SUBJECT: ISSUANCE OF AMENDMENT NOS. 109 AND 85 TO FACILITY OPERATING LICENSE
NOS. DPR-51 AND NPF-6 FOR ARKANSAS NUCLEAR ONE, UNIT NOS. 1 AND 2
(TAC NOS. 66716 AND 66718)

AMENDMENT TO FACILITY OPERATING LICENSE

ATTACHMENT TO LICENSE AMENDMENT NO. 109

SAFETY EVALUATION BY THE OFFICE OF NUCLEAR REACTOR REGULATION
RELATED TO AMENDMENTS NOS. 109 AND 85 TO FACILITY OPERATING LICENSE
NOS. DPR-51 AND NPF-6
ARKANSAS POWER AND LIGHT COMPANY
ARKANSAS NUCLEAR ONE, UNIT NOS. 1 AND 2
DOCKET NOS. 50-313 AND 50-368

FIGURE 6.2-1 MANAGEMENT ORGANIZATION CHART

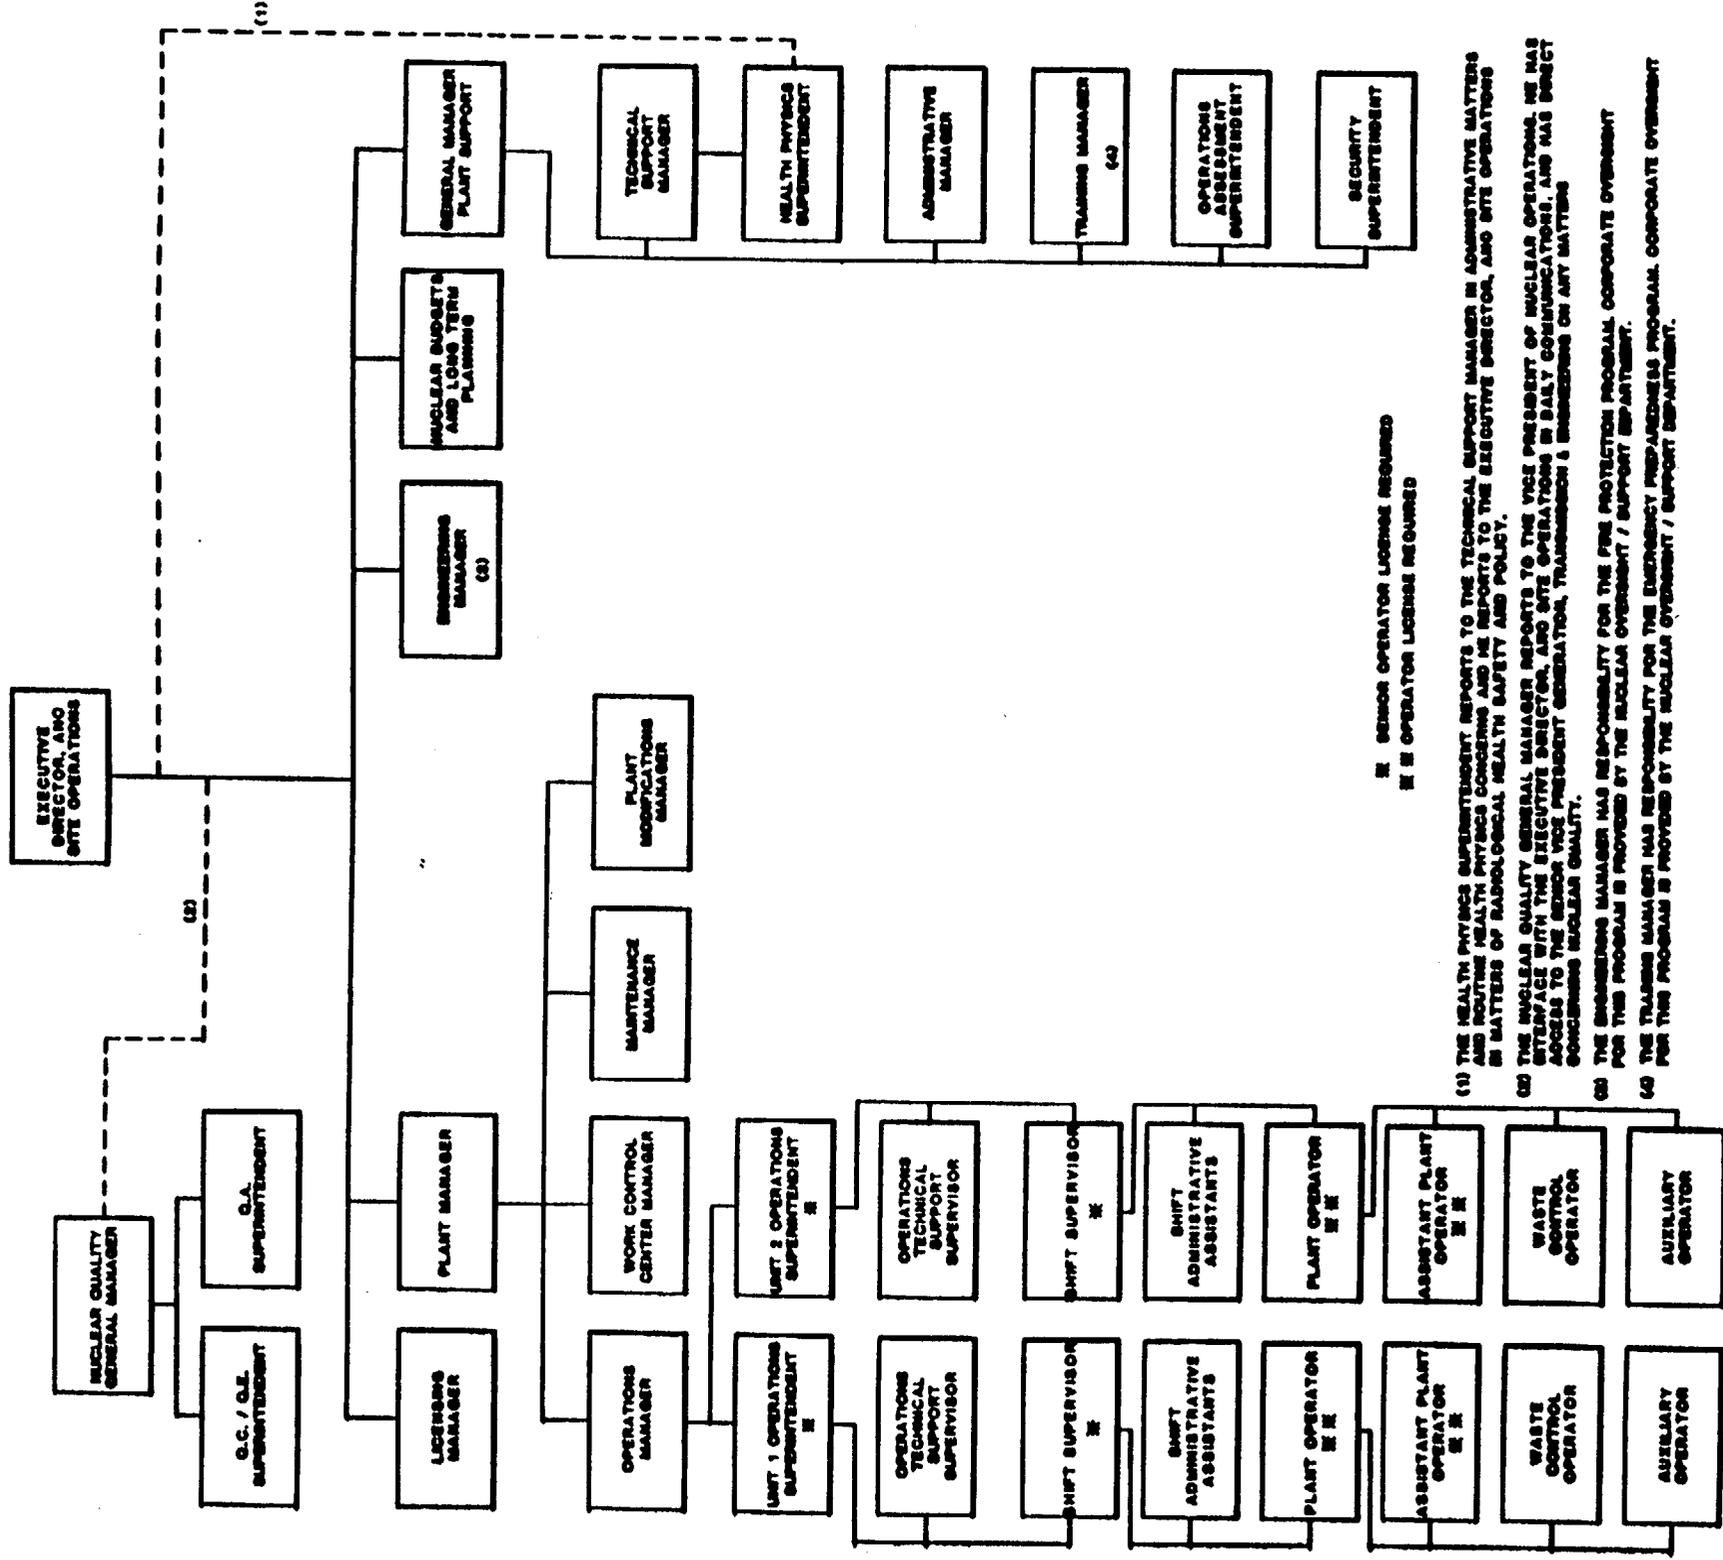
a. Figure 6.2-1 Management Organization Chart

Changes to the Nuclear Operations Department which reports directly to the Senior Vice President, Generation Transmission and Engineering, are briefly described below.

- (1) The Design Engineering Department is created and reports directly to the Vice President, Nuclear Operations. It performs the design engineering support function for nuclear operations formerly handled by the Engineering Department, which is no longer depicted on Figure 6.2-1, since it no longer has a nuclear support function.
- (2) The Nuclear Services Department is deleted. Additionally, the positions of Nuclear Programs Manager, Nuclear Services Manager, and Nuclear Engineering and Licensing Manager are deleted. The functions assigned to these groups included nuclear engineering, licensing, corporate off-site health physics, corporate fire protection, and emergency preparedness.

- Nuclear engineering - Design Engineering Department
 - Licensing - Licensing Department (described below)
 - Emergency preparedness, fire protection, and Corporate Health Physics - Nuclear Oversight/Support Department (described below)
- (3) The Nuclear Oversight/Support Department is created and reports directly to the Vice President, Nuclear Operations. The principal functions of this department are to provide staff support for the Safety Review Committee (SRC) and to provide corporate management oversight of various line functions.

As noted above, this new department will also perform the function of Corporate Health Physics. Because of this the "dotted line" responsibility from the Health Physics Superintendent to the now deleted Nuclear Programs Department Manager that was depicted on both Figures 6.2-1 and 6.2-2, is removed.

The staff has reviewed the organization changes just described. The placing of the design engineering function for support of nuclear operations under direct control of the Vice President, Nuclear Operations, is viewed as a positive step which should result in more effective and direct support to the ANO site engineering and operations organizations.

The staff concludes that: (1) the proposed organizational structure provides for the integrated management of activities that support the safe operation and maintenance of the facilities, and (2) clear management control and effective lines of authority and communications exist between the organizational units involved in the management, operation, and technical support for the operation of the facilities. Therefore, the above described changes meet the applicable acceptance criteria of Section 13.1.1, "MANAGEMENT AND TECHNICAL SUPPORT ORGANIZATION", of the SRP and are acceptable to the staff.

FIGURE 6.2-2 FUNCTIONAL ORGANIZATION FOR PLANT OPERATIONS

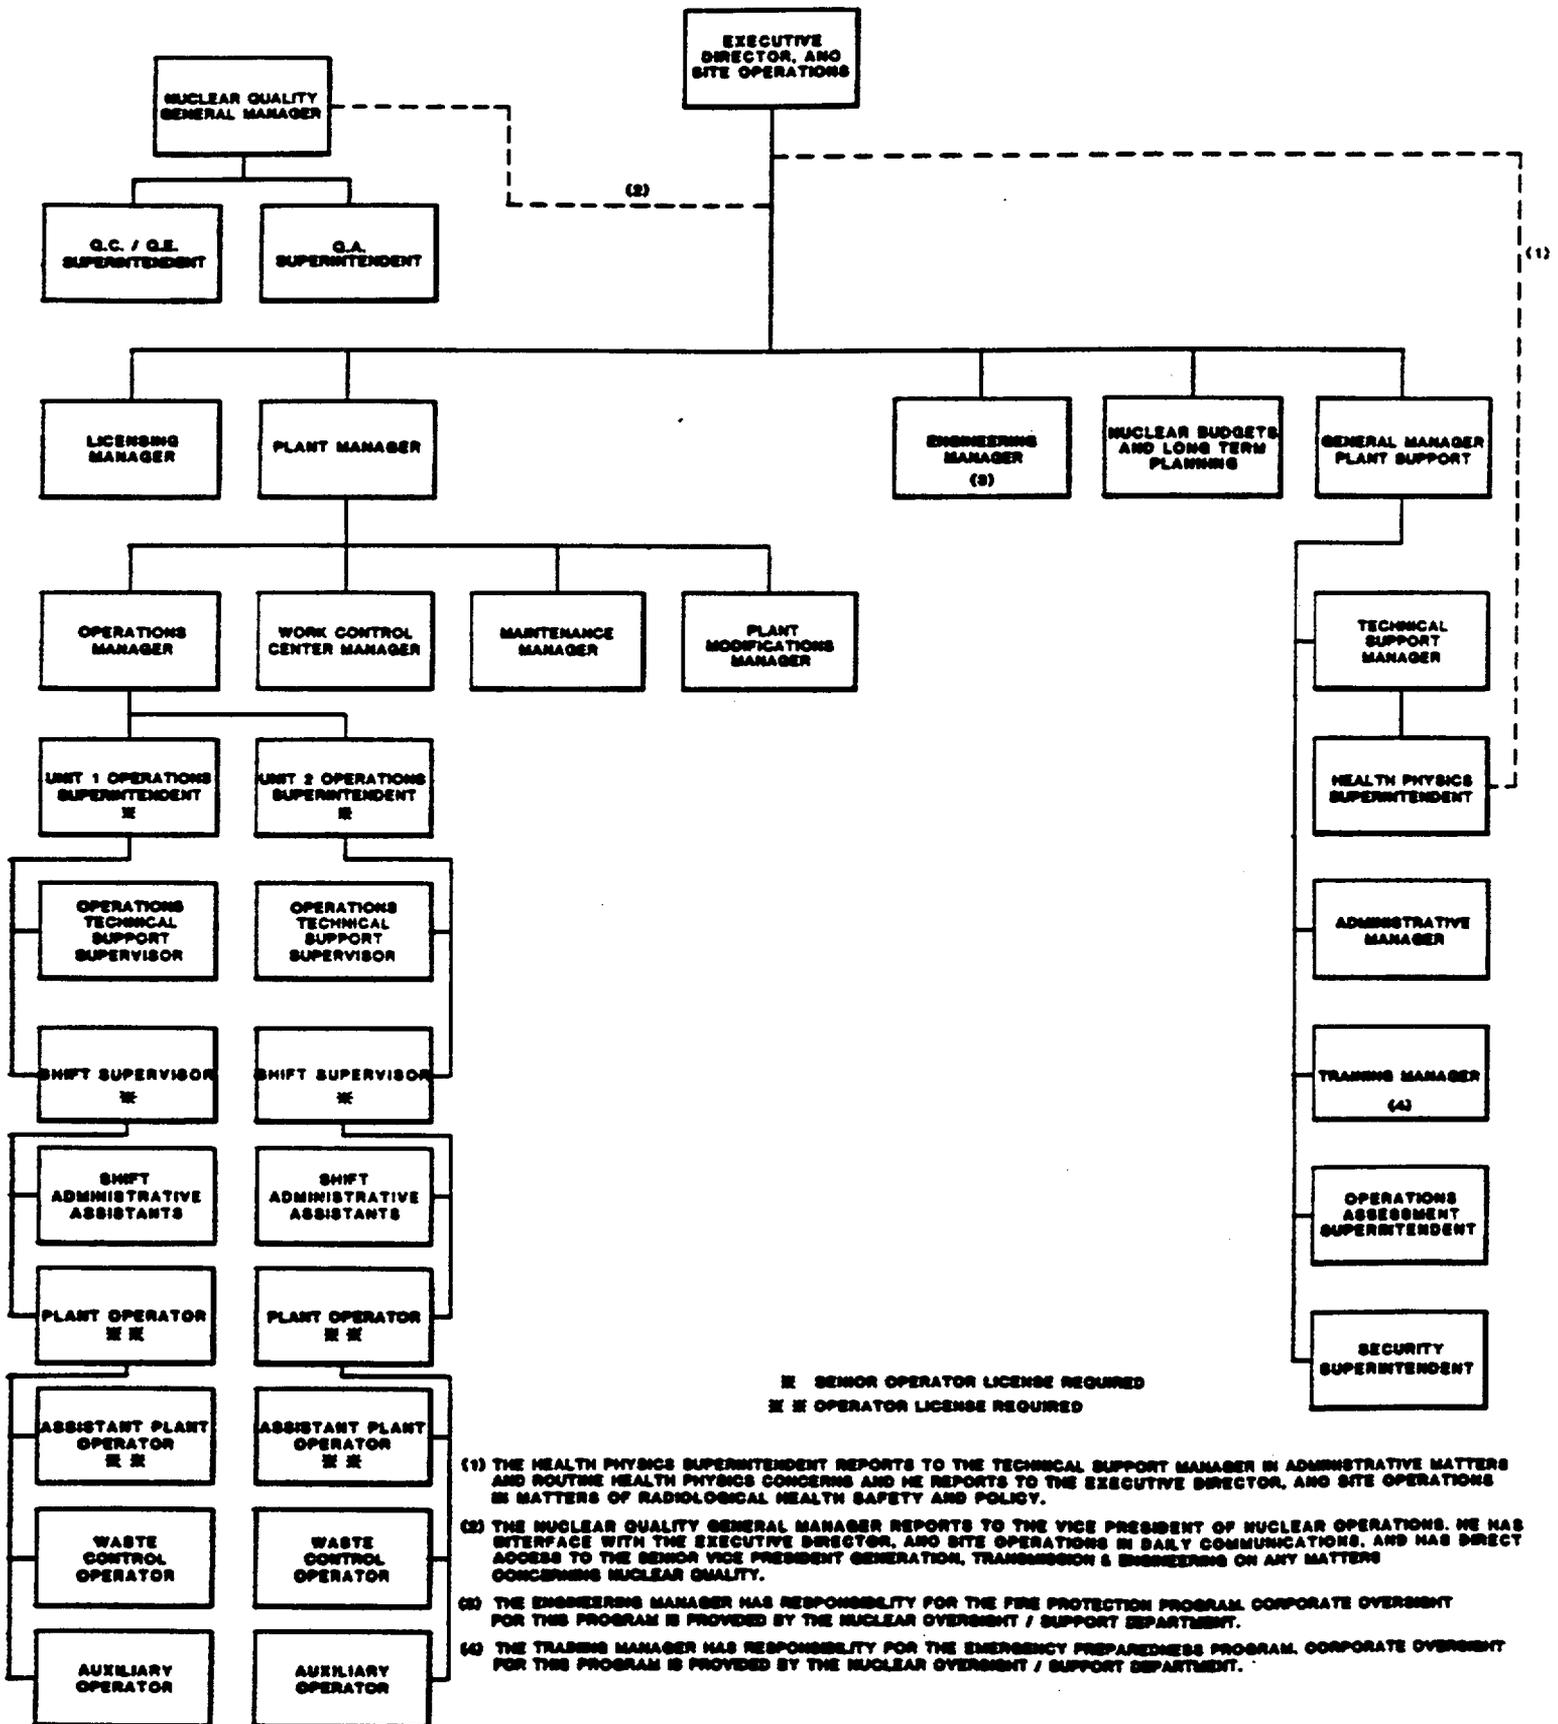
Also, as noted above, the corporate oversight for both fire protection, and emergency preparedness are provided by the Nuclear Oversight/Support Department. This is depicted on Figure 6.2-2.

b. Figure 6.2-2 Functional Organization for Plant Operations

Changes to the onsite organization are briefly described below.

- (1) The position of Special Projects manager has been deleted. The onsite Licensing group which previously reported to the Special Projects Manager, is combined with the corporate Licensing group, under a single Licensing Manager who reports directly to the Executive Director, ANO Site Operations.
- (2) The Plant Modifications Manager who formerly reported directly to the Executive Director, ANO Site Operations, now reports to the Plant Manager. This allows the Plant Manager to better integrate modification activities with other day to day operations and maintenance activities.
- (3) The Engineering Manager, formerly reporting to the General Manager, Plant Support, now reports directly to the Executive Director, ANO Site Operations, reflecting increased emphasis on engineering support for operation and maintenance activities.

- (4) The Nuclear Budgets and Long Term Planning Department is created, reporting directly to the Executive Director, ANO Site Operations.
- (5) Portions of the subtier organizations within Maintenance, Engineering, and Plant Support have been deleted to allow future minor organizational changes without the need for a license amendment. For the same reason, some management titles have been replaced with the corresponding group or department title to show organizational function.

The staff has reviewed these changes and it appears they will enhance the effectiveness of the onsite management organization, particularly in the plant modifications and plant engineering support functions. In addition, the proposed site organization still maintains clear lines of authority to the Executive Director, Site Nuclear Operations and responsibility for all activities important to the safe operation of the facilities. Therefore, these changes meet the applicable acceptance criteria of Section 13.1.2 "OPERATING ORGANIZATION," and are acceptable to the staff.
